Project	<b>IEEE 802.16 Broadband Wireless Access Working Group</b> < <a href="http://ieee802.org/16">http://ieee802.org/16</a> >	
Title	<b>FAST_FEEDBACK Channel Codeword Extension</b>	
Date Submitted	<b>2004-07-08</b>	
Source(s)	Myung-Kwang Byun, Seungjoo Maeng, Jaeho Jeon, Soonyoung Yoon, Panyuh Joo	<a href="mailto:mk.byun@samsung.com">mk.byun@samsung.com</a>
	<p>Samsung Electronics Co., Ltd.  Dong Suwon P.O.Box 105  416, Maetan-3dong, Yeongtong-gu,  Suwon-city, Gyeonggi-do, Korea  442-600</p>	
Re:		
Abstract	FAST_FEEDBACK Channel Codeword Extension	
Purpose	Adopting of proposed method into P802.16e	
Notice	This document has been prepared to assist IEEE 802.16. It is offered as a basis for discussion and is not binding on the contributing individual(s) or organization(s). The material in this document is subject to change in form and content after further study. The contributor(s) reserve(s) the right to add, amend or withdraw material contained herein.

## FAST\_FEEDBACK Channel Codeword Extension

Figure bb1—Subcarrier Mapping of FAST\_FEEDBACK Modulation Symbols for PUSC

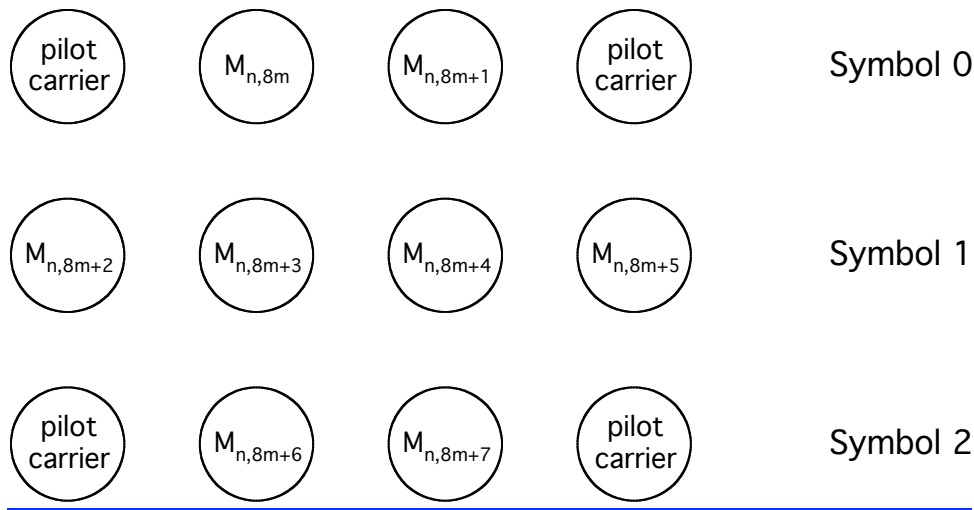
$M_{n,8m+k}$  is mapped to FAST\_FEEDBACK channel tile as shown in Figure bb1 for PUSC uplink subchannel and in Figure bb2 for optional PUSC uplink subchannel. A FAST\_FEEDBACK channel is mapped to one subchannel composed of 6 tiles.

Figure cc—Mapping of MIMO coefficients for fast MIMO feedback payload bits

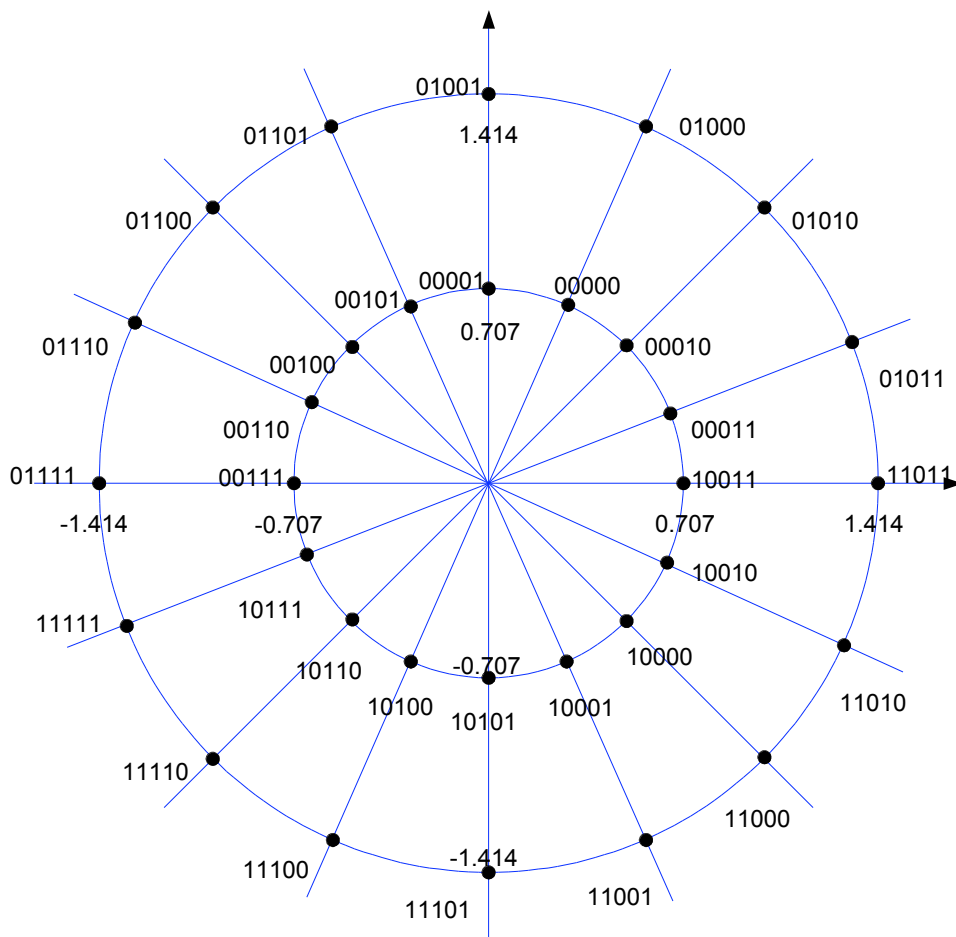
When the FAST\_FEEDBACK subheader Feedback Type field is ‘01’ or ‘10’ the SS shall report the MIMO coefficient the BS should use for best DL reception (see 8.4.8.1.6). The mapping for the complex weights is shown in Figure cc.

Figure bb1 — Subcarrier Mapping of FAST\_FEEDBACK Modulation Symbols for PUSC

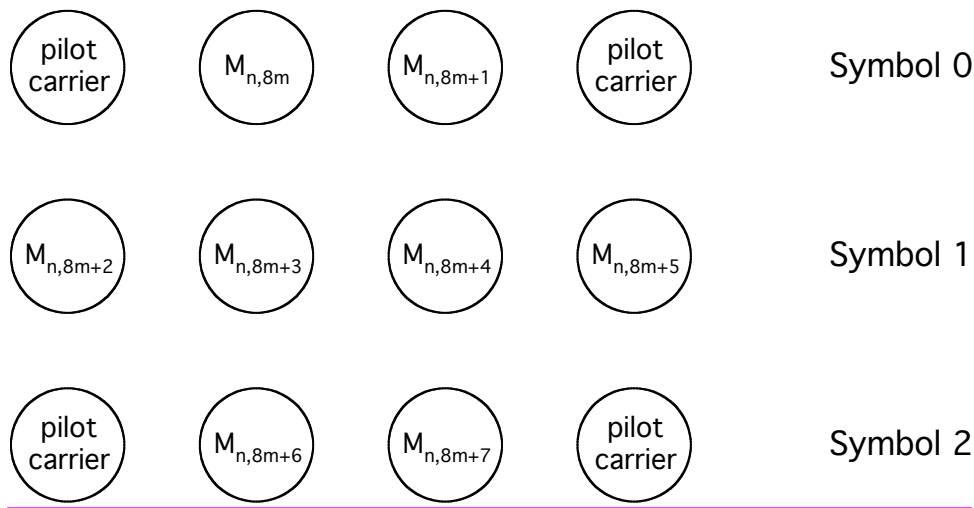
$M_{n,8m+k}$  is mapped to FAST\_FEEDBACK channel tile as shown in Figure bb1 for PUSC uplink subchannel and in Figure bb2 for optional PUSC uplink subchannel. A FAST\_FEEDBACK channel is mapped to one subchannel composed of 6 tiles.

Figure cc—Mapping of MIMO coefficients for fast MIMO feedback payload bits

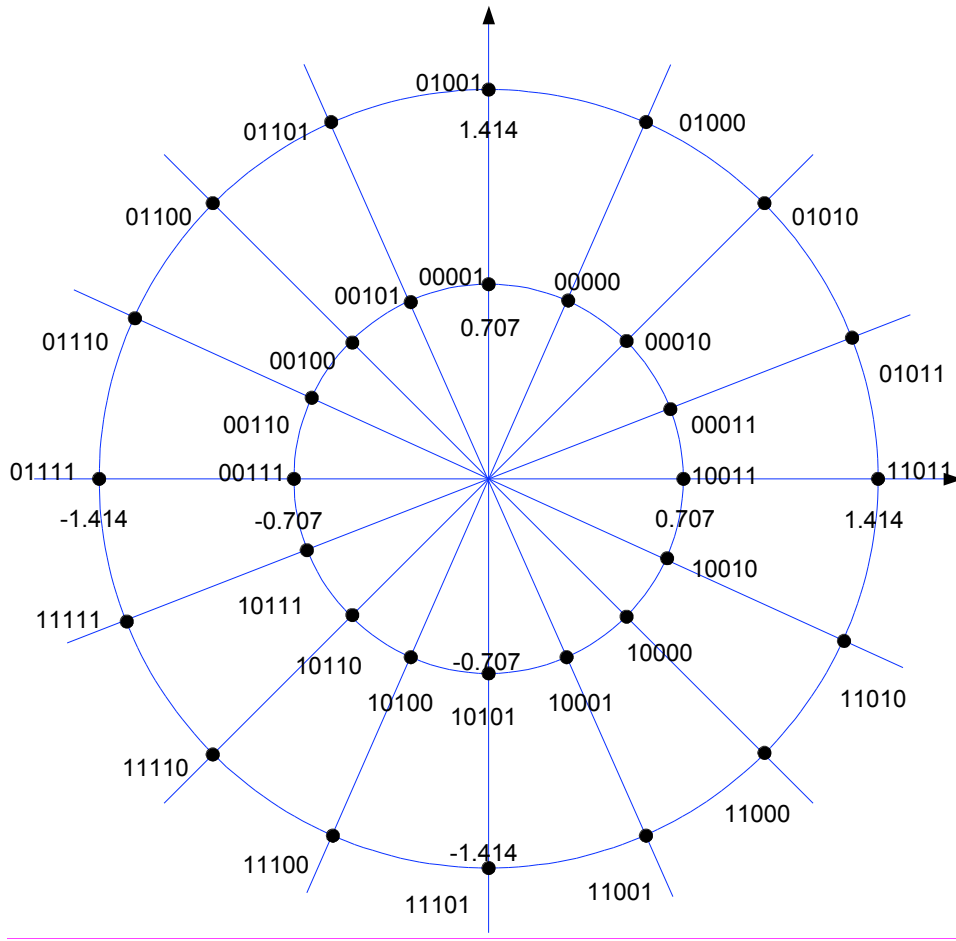
When the FAST\_FEEDBACK subheader Feedback Type field is ‘01’ or ‘10’ the SS shall report the MIMO coefficient the BS should use for best DL reception (see 8.4.8.1.6) or send its selection in terms of MIMO mode (STTD versus SM) or permutation mode on the assigned FAST\_FEEDBACK channel. For the first 32 codewords, the mapping for the complex weights is shown in Figure cc.

For the remaining codewords, see 8.4.5.4.10.3.
